## Riley Purgatory Bluff Creek Watershed District Permit Application Review

**Permit No:** 2021-078

**Project:** Shoreline Stabilization – The applicant proposes maintenance of existing stabilization elements along about 90 feet of Lotus Lake shoreline.

**Reviewer:** Scott Sobiech, PE, Barr Engineering

**SHORELINE REHABILITATION PLAN**

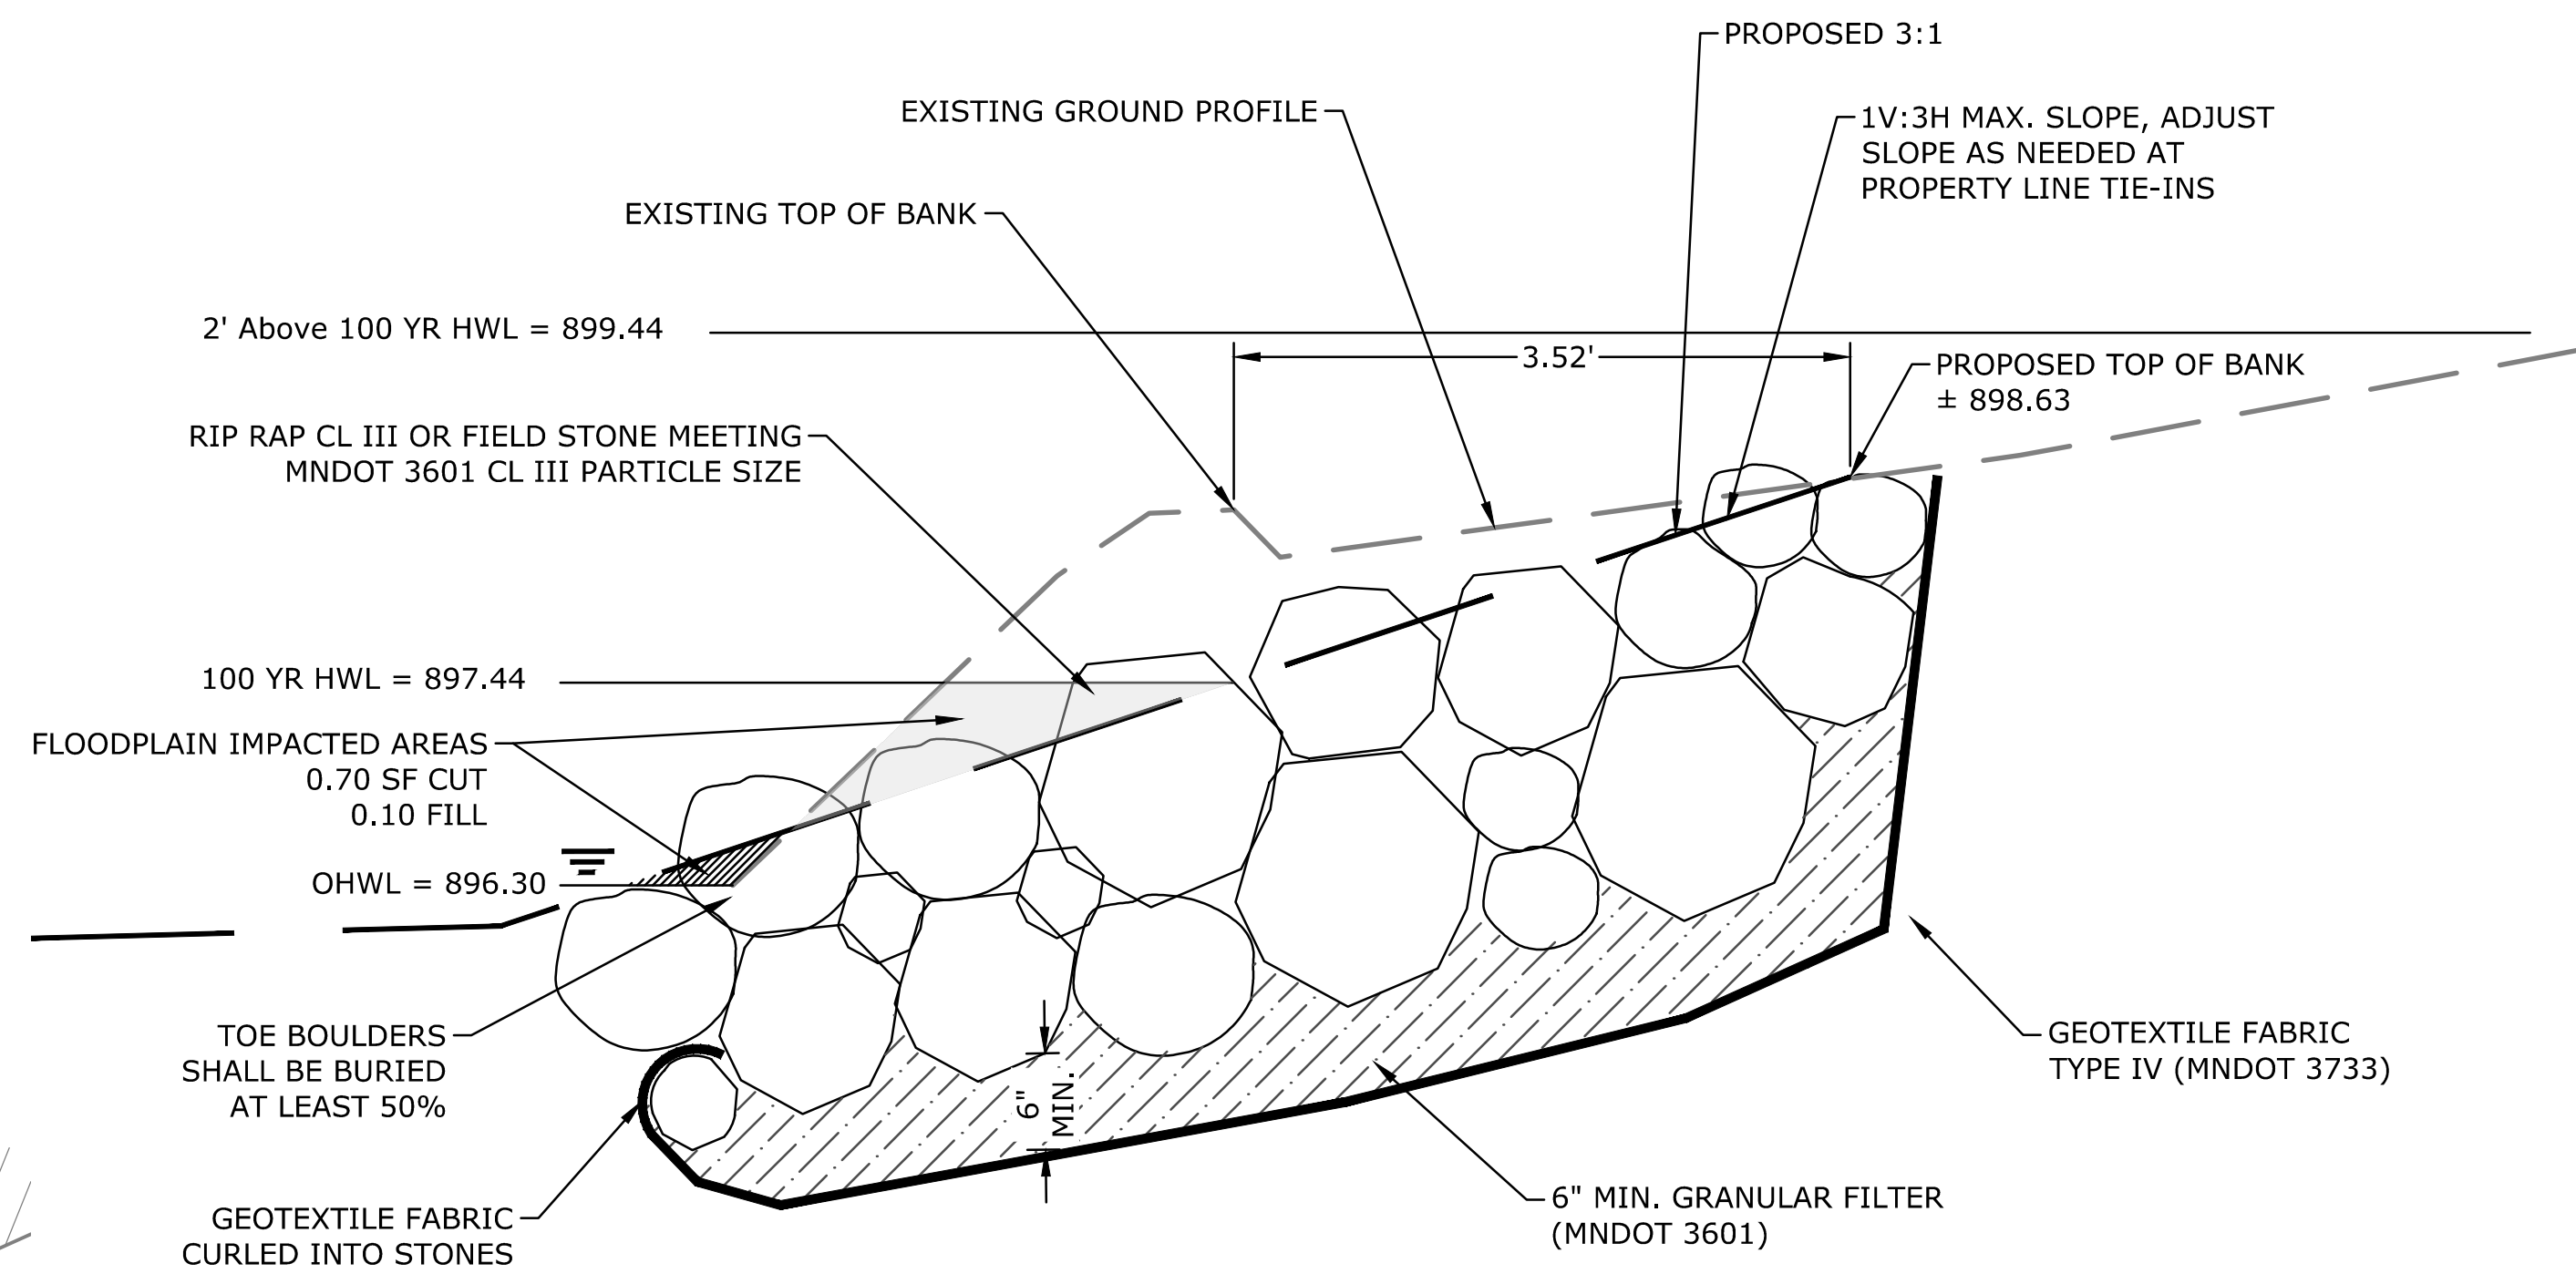
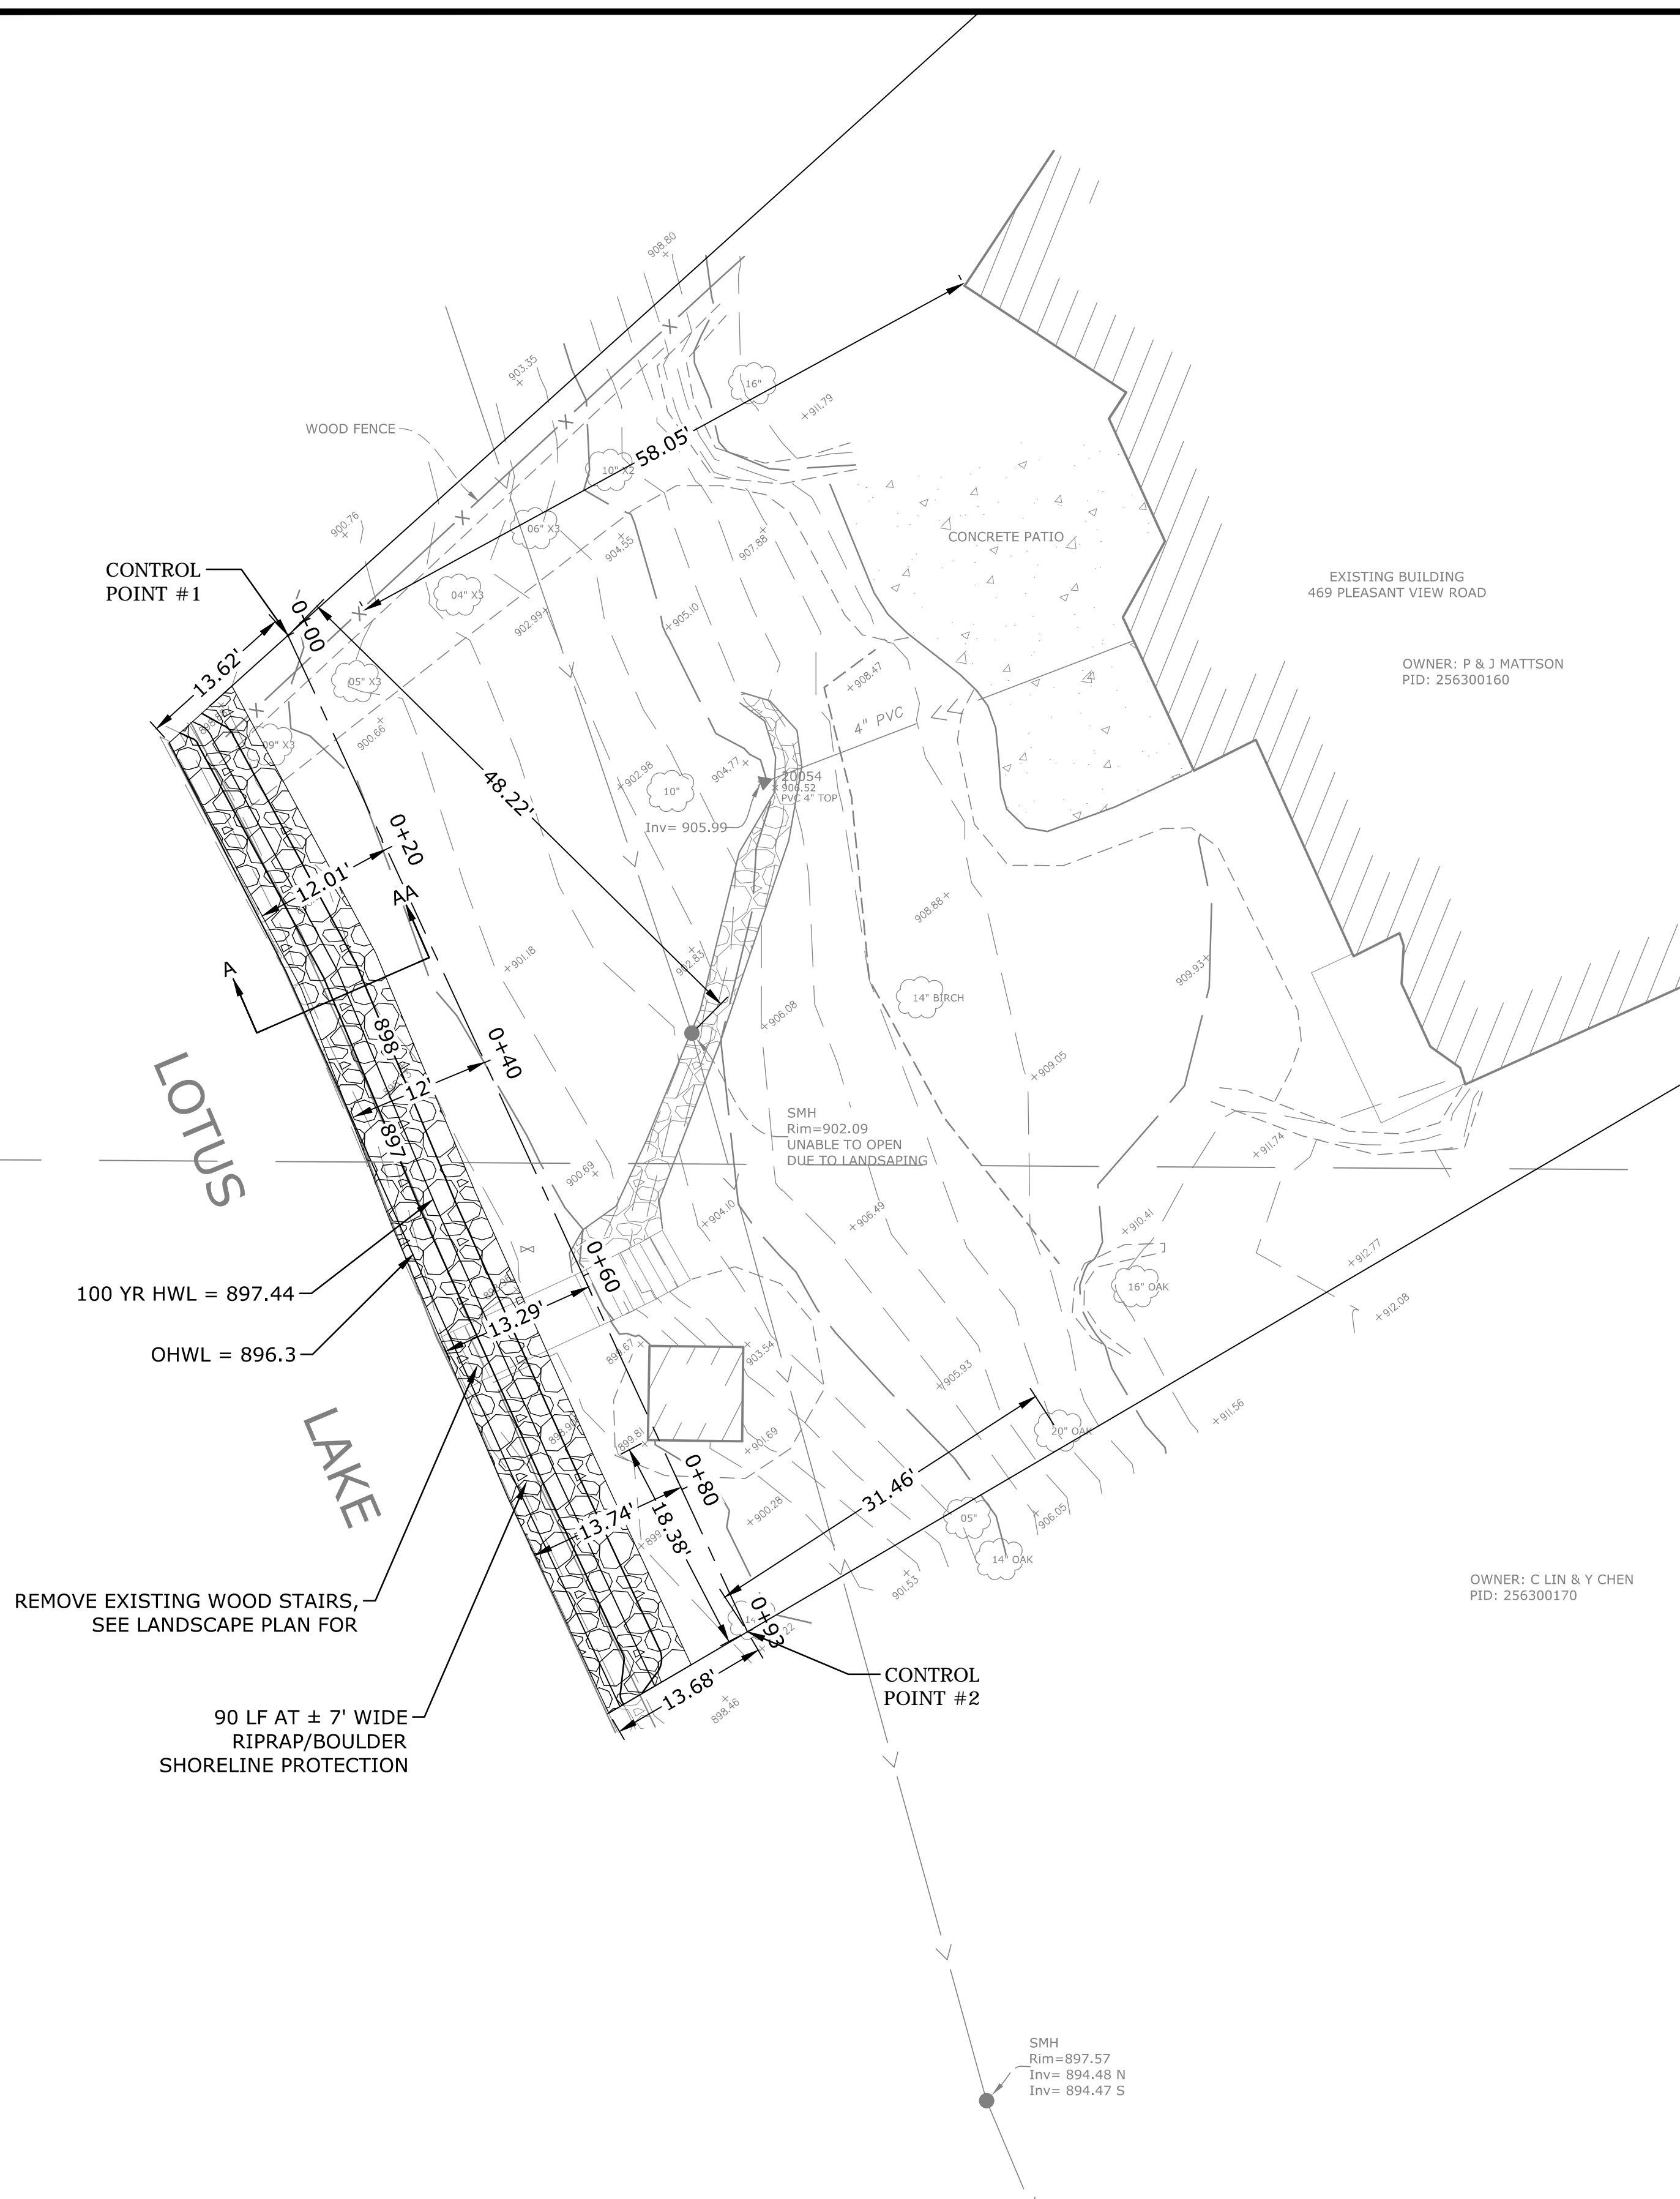
Engineer concurs, that 9.7 cubic feet of fill will be placed to facilitate riprap placement, and 63 cubic feet of excavation to create the compensatory storage below the 100-year floodplain of Lotus Lake, thus the project provides a net increase in floodplain storage and conforms to Rule B, Subsection 3.2. Because the applicant has demonstrated and the engineer concurs that the project will preserve the existing 100-year flood level, the project will not alter surface flows, complying with subsection 3.3.

The design plans, which are certified by a registered engineer, call for fieldstone riprap along 90 feet of shoreline. Because the proposed slope shown on the design plan is 3:1 (horizontal to vertical) or flatter waterward of the ordinary high water level, the project conforms to Rule F, Subsection 3.3.a.ii. The drawings show the proposed stabilization will follow the configuration of the existing shoreline. The

design plan indicates no riprap or filter material will be placed more than six (6) feet waterward of the ordinary high water level (OHW) of elevation 896.3. As a result the proposed project conforms to Rule F, Subsection 3.3.a.iii.

Master Backyard

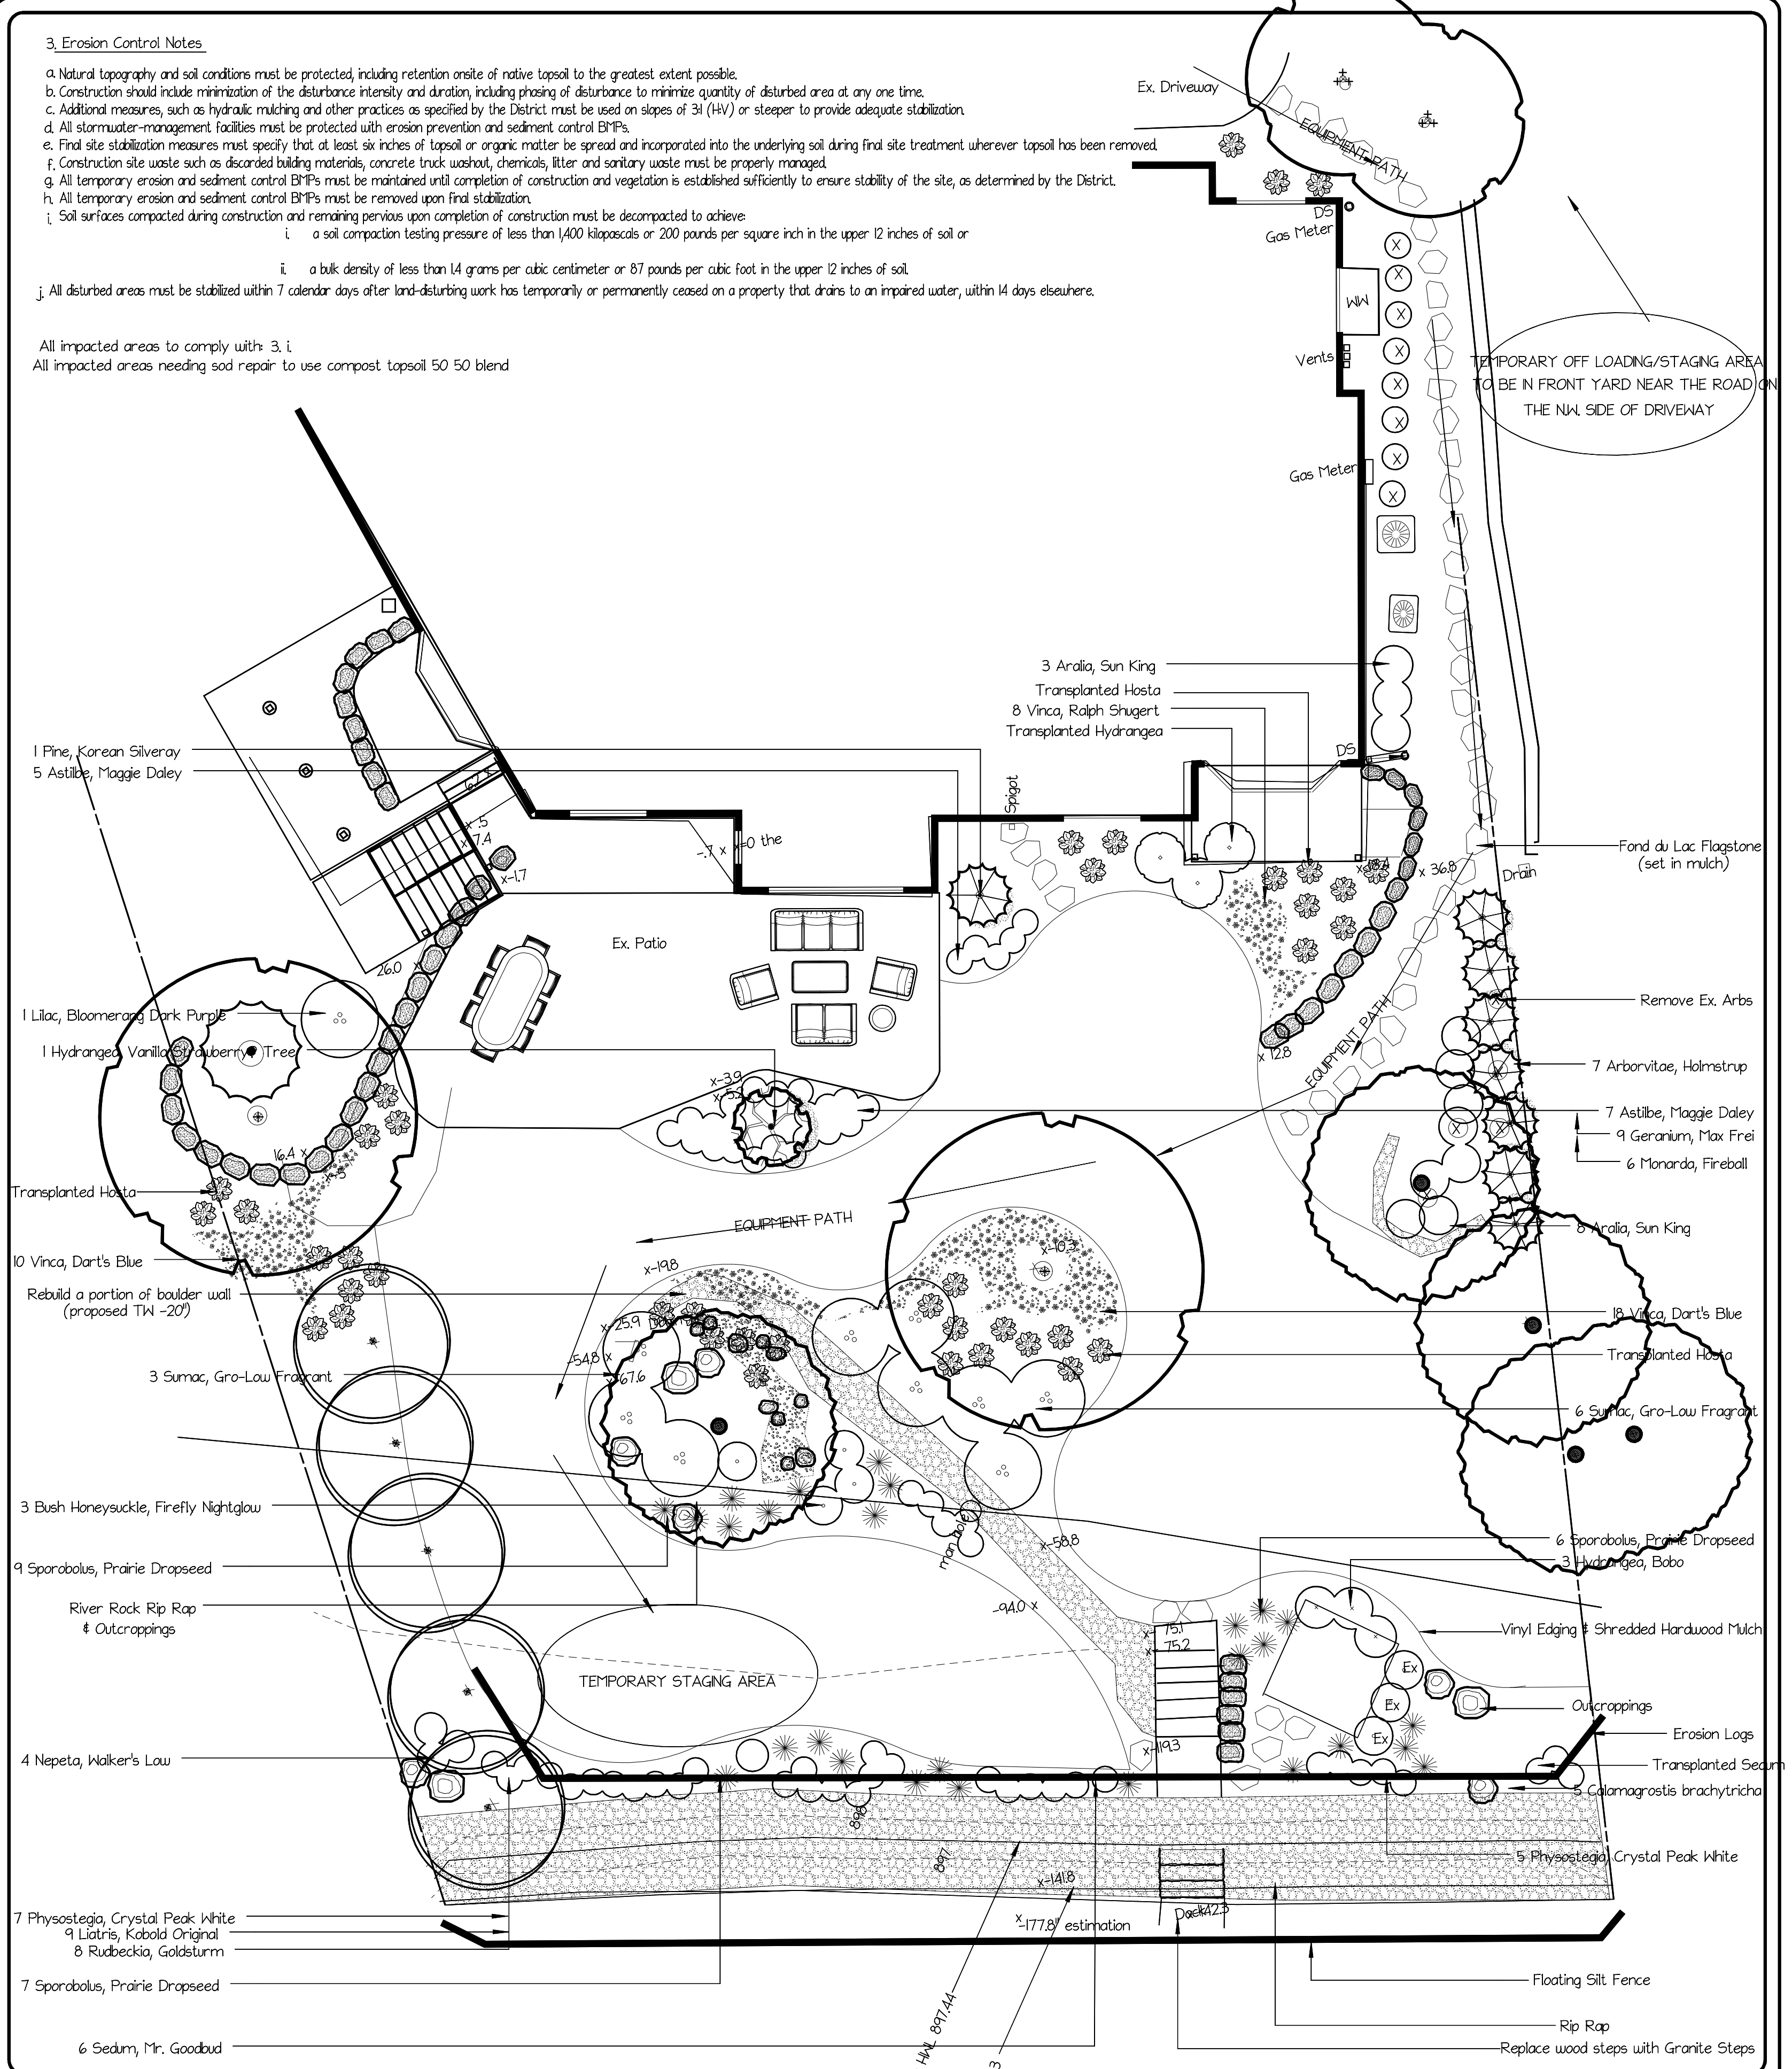
- B1. The Applicant must provide updated plans requiring activities be conducted so as to minimize the potential transfer of aquatic invasive species (e.g., zebra mussels, Eurasian watermilfoil, etc.) to the maximum extent possible..

The drawing prepared by C. Johnson Landscape Design Group LLC includes installation of floating silt curtain, installation of a construction entrance, placement of a minimum of 6 inches of topsoil, and decompaction of areas compacted during construction. To conform to the RPBCWD Rule C requirements the following revisions are needed:
